Re: SSD 79276958 \_ 59-63 Trafalgar Avenue and 1A & 1B Valley Road Lindfield

**Subject: Design quality review submission to support an objection by the owner of 36 Middle Harbour Road Lindfield**

SSD 79276958  
Residential  
Development with  
Affordable Housing

Project Address:  
59-63 TRAFALGAR AVENUE  
1A&1B VALLEY ROAD  
LINDFIELD

FIGURE 2

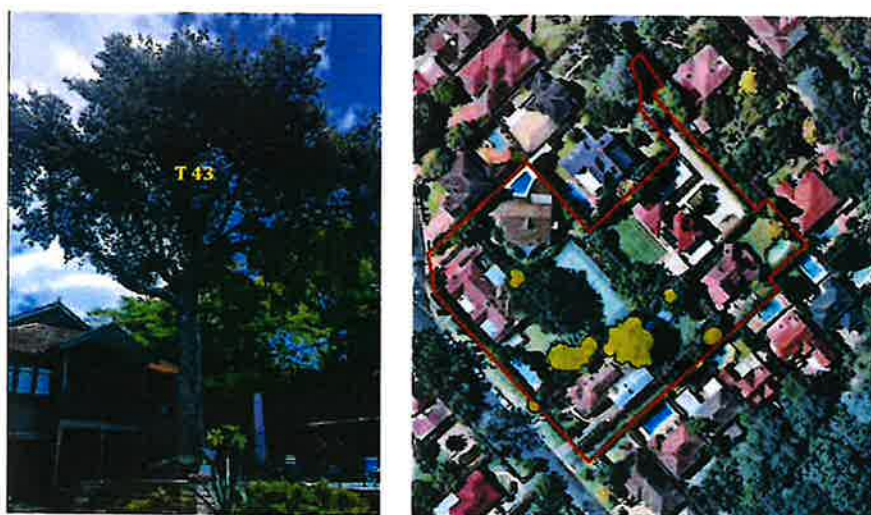
The site contains a significant Sydney Turpentine tree (T43 BDAR) and the application provides no *"evidence that opportunities to retain significant trees have been explored and/or inform the plan"* as required by the SEARS. This tree is endemic to the area and is a dominant tree in the endangered plant community type (STIF). It would

FIGURE 12: BUILT FORM INFORMATION PRESENTED AT THE MARCH COMMUNITY INFORMATION WEBINAR

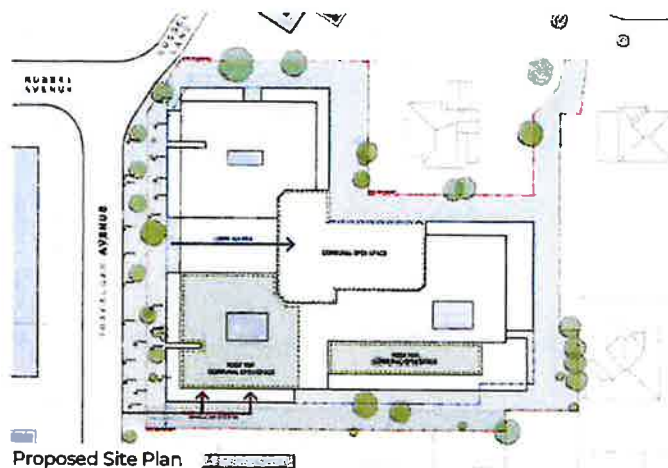
- The webinar session stated design principles including "built form was designed to be responsive to the existing surroundings, minimising amenity impacts on neighbouring properties" when in fact structure plan will impact solar access to dwellings to the southern boundary, which currently receive 6 hours mid-winter sun, reduced to receive ½ hour to 2 hours solar access to private open space and living areas.

- The *Ethos Urban Consultation Outcomes Report 5.0 Feedback and Project Response* incorrectly states that "that proposal has been designed to generally comply with height and setback controls, ensuring the neighbour's solar access, privacy and views are maintained in alignment with per planning regulations" and that this was achieved in a number of ways including "Strategically shaping the building's mass to maximise solar access to adjoining properties." Refer Figure 12.

FIGURE 16: DKO DESIGN VERIFICATION REPORT 10AM SUN EYE

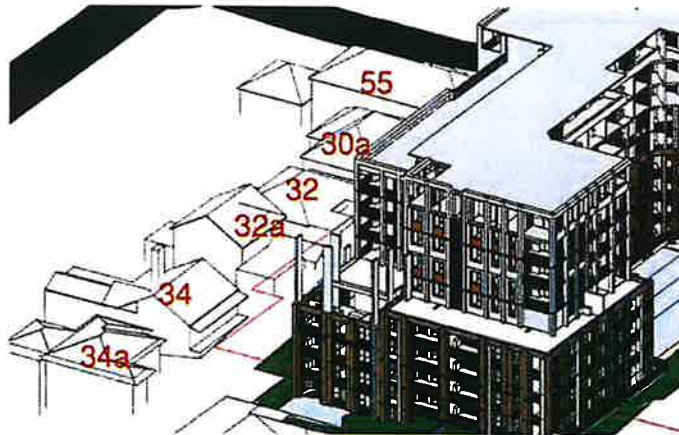
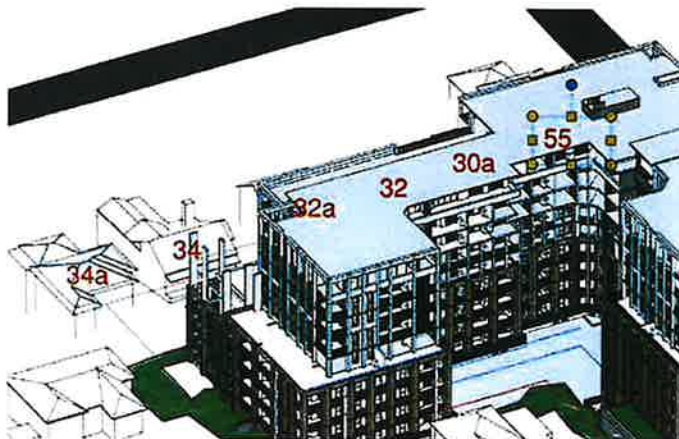
Reviewing the sun eye diagrams the properties with rear gardens facing the subject site southern boundary are unreasonably overshadowed between 9am and 3pm mid-winter. The above mentioned properties are fully overshadowed after 12pm

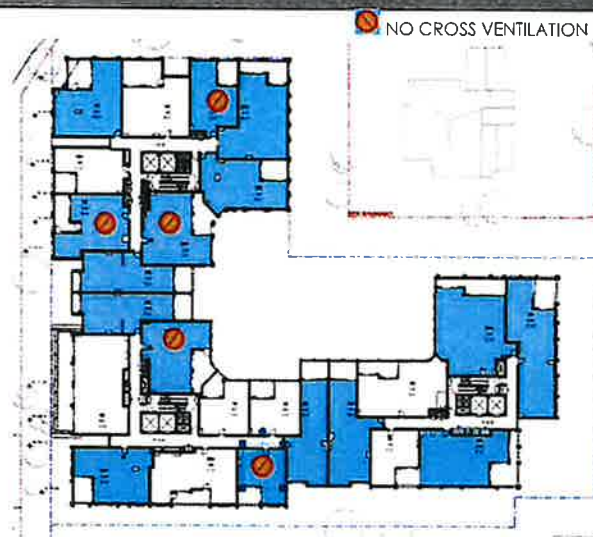
The proposal delivers **87 (43.7%)** naturally cross ventilated apartments.

Excerpt from DKO Design Verification indicating apartments not capable of complying with ADG cross ventilation objectives.

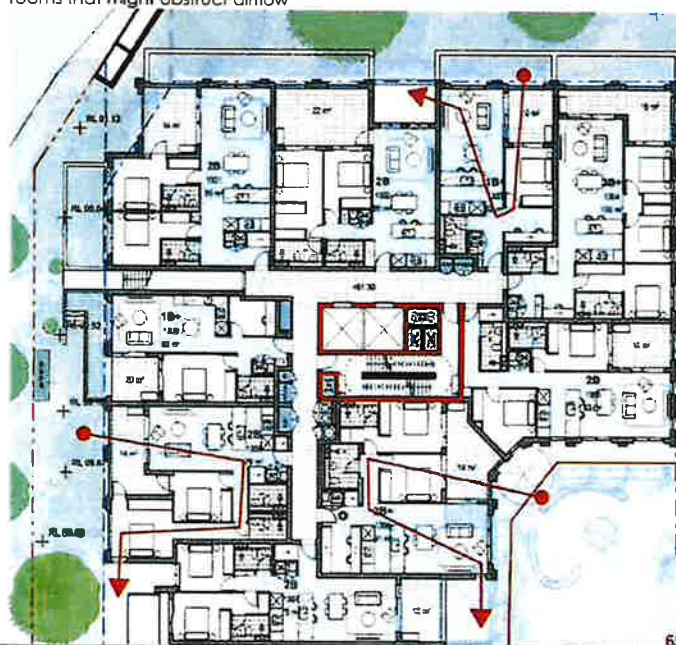
Natural flow paths shown in red are optimistic and in my view unworkable.

Excerpt from DKO Architectural Plans above with my overlay in red indicating apartments cross ventilation pathways not capable of complying with ADG cross ventilation objectives.
